Town Council Regular Meeting | 5:30 PM

Wednesday, February 18, 2026

E. Resolution No. 13 - Series 2026 Maloit Park Exemption Tract A Eagle County School District Subdivision - Preliminary Plat

SHEET NO.
C1.1

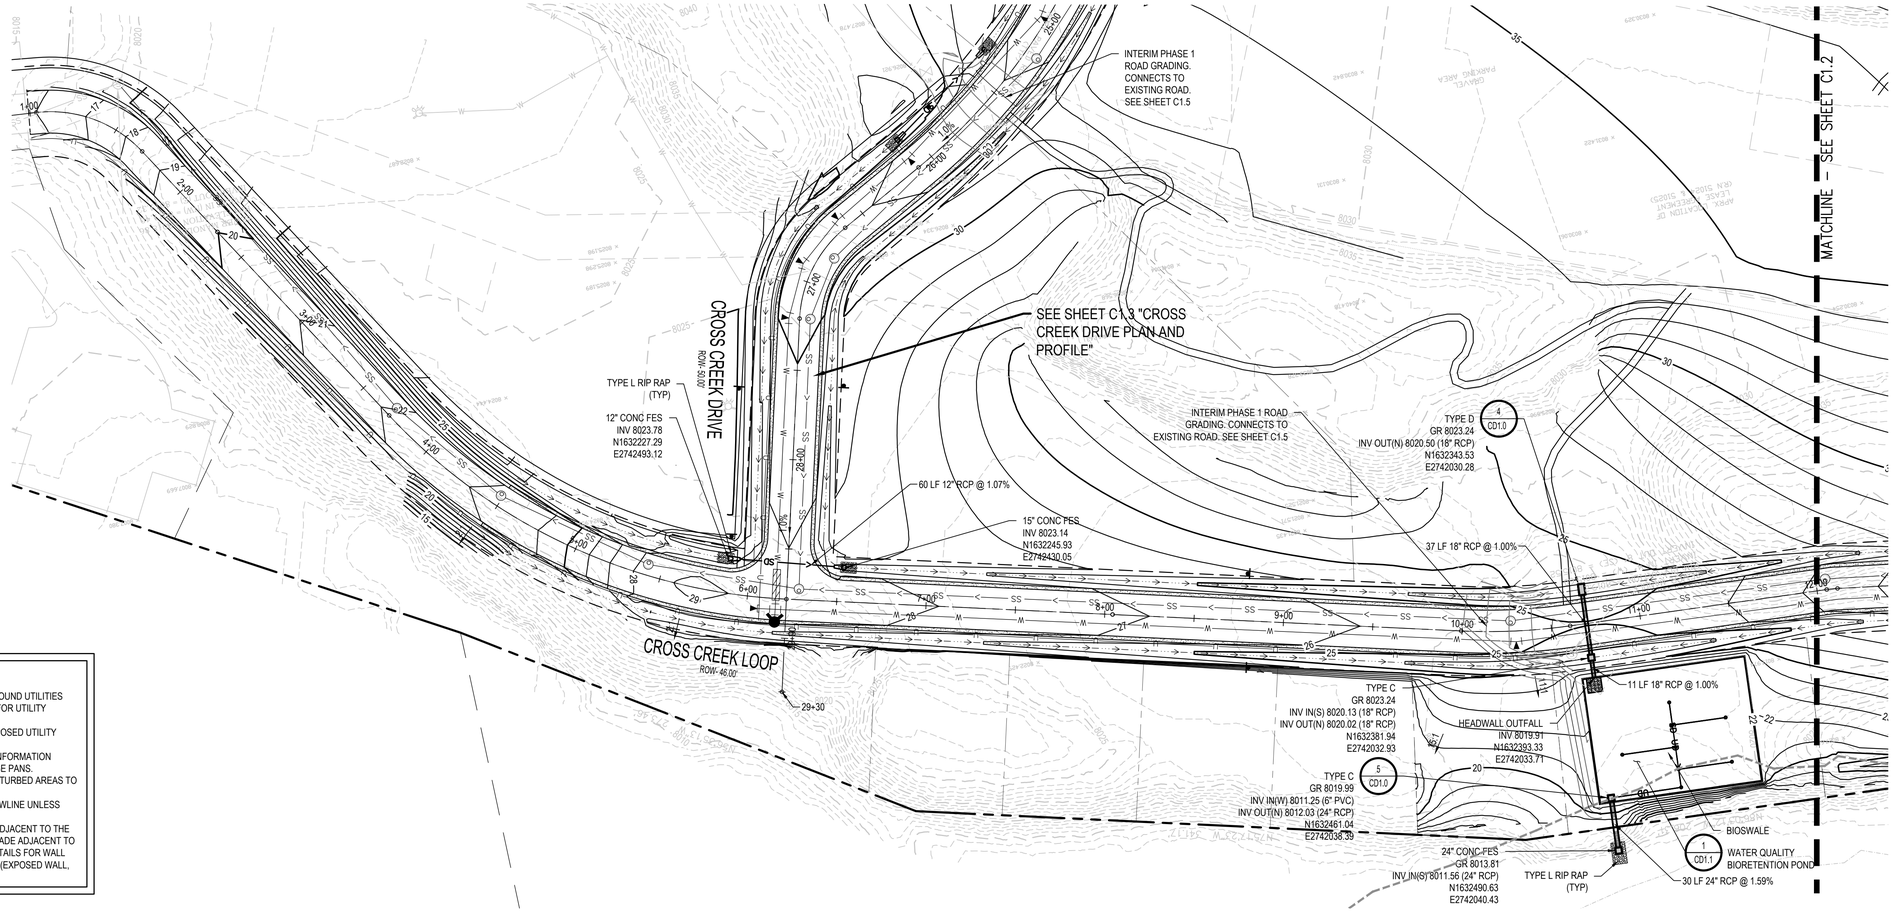
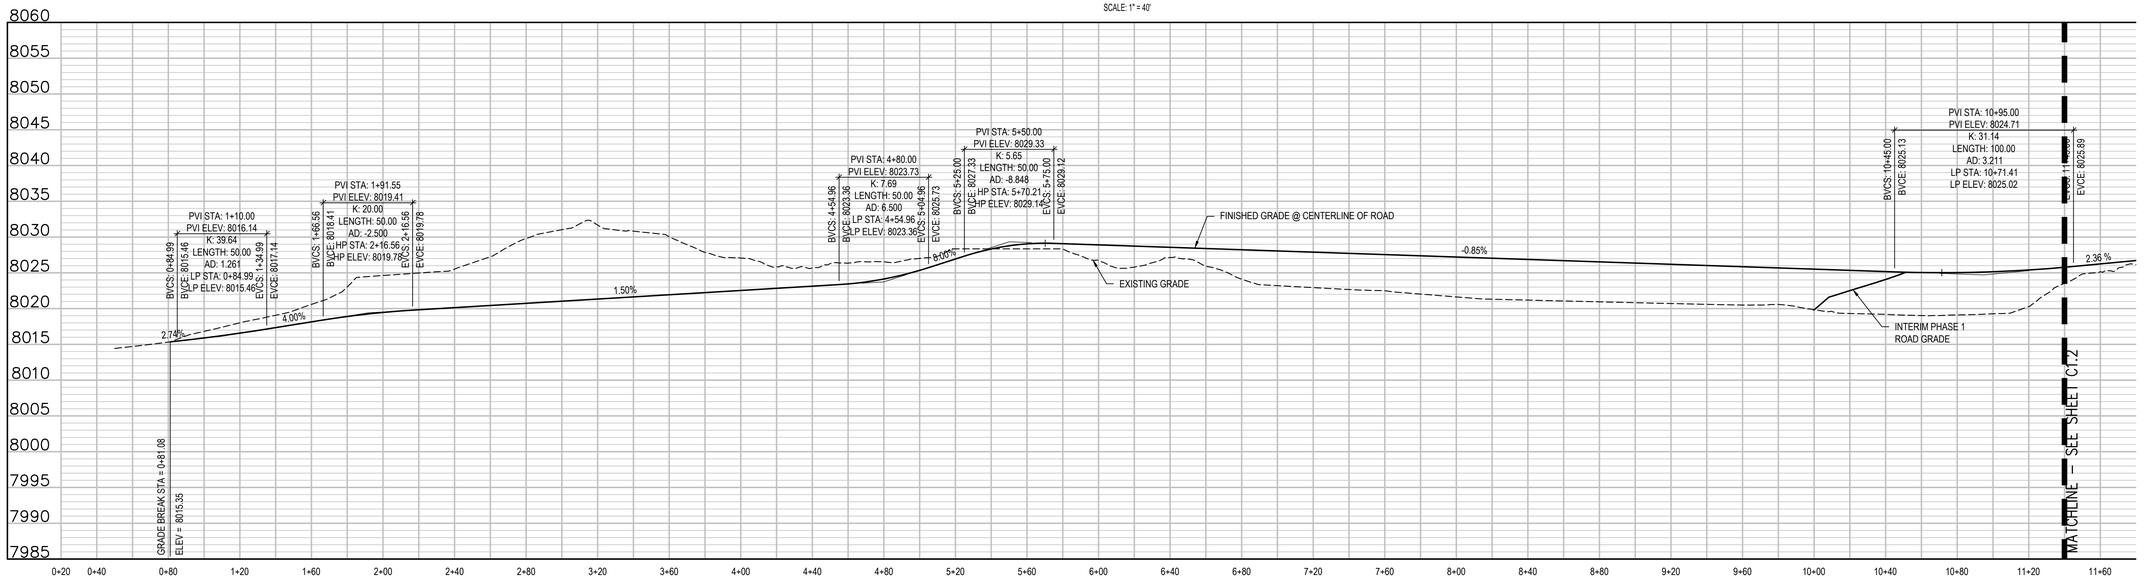
On Sheet No. C1.1 – Cross Creek Loop Plan and Profile, the road names differ from what is shown on the plat. This should be corrected to align with the preliminary plat.

SHEET NO.
C1.2

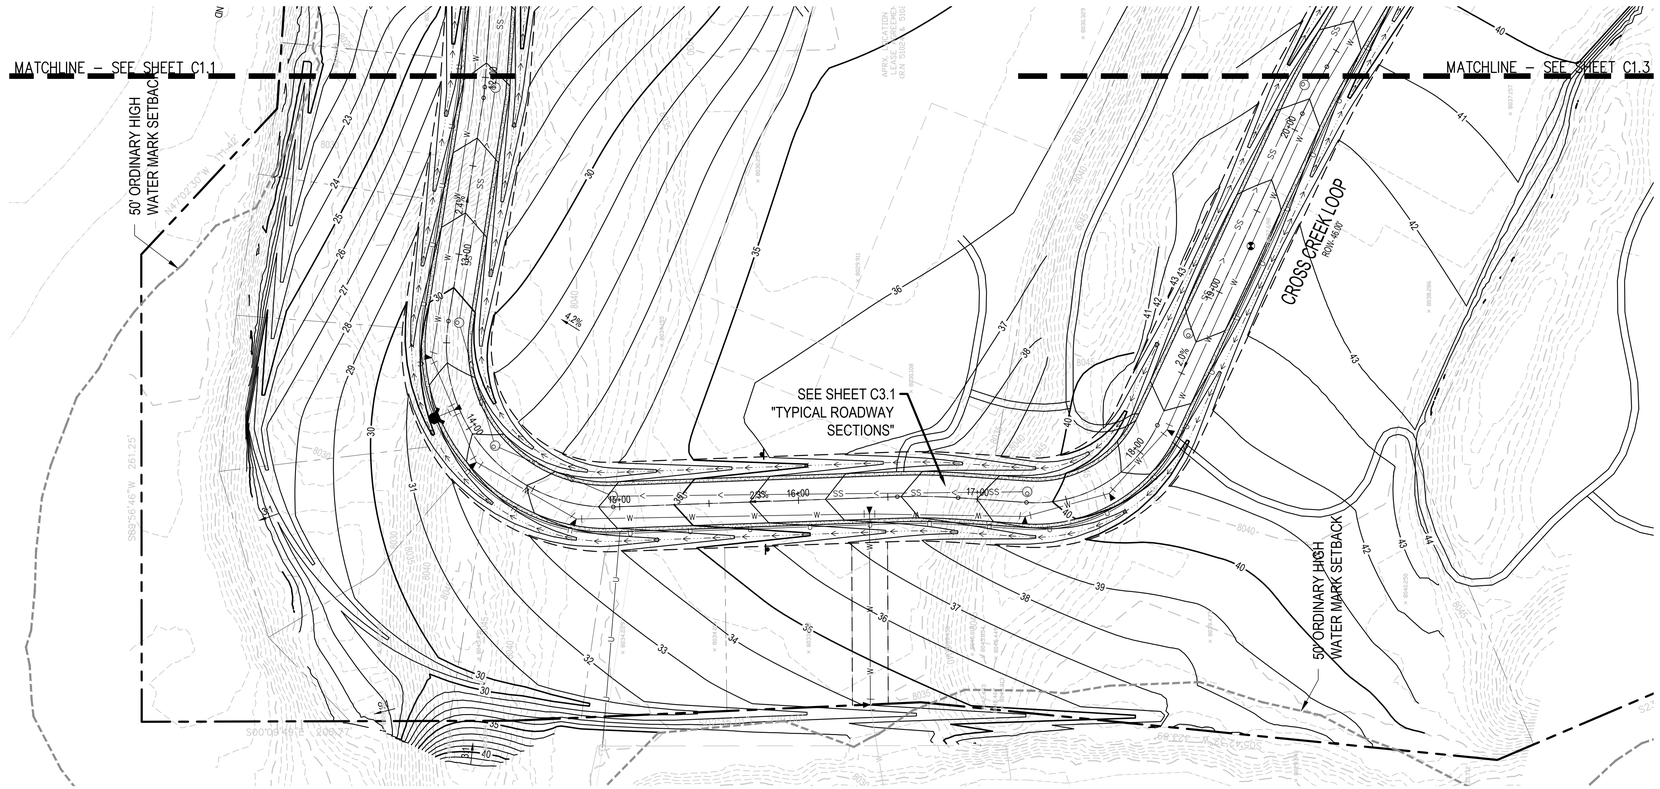
On Sheet No. C1.2 – Road A Plan and Profile, the line with the "U" labeling should read "UE" for underground electric according to the design legend on Sheet No. C0.1. Additionally, the meaning of the hatched lines should be identified on this sheet or removed. If the hatched lines indicate structures or facilities to be demolished, if possible, these should be shown only on the demolition plans and not in the remainder of the Plan Set sheets. Please remove any repetitive hatched lines from the construction plans.
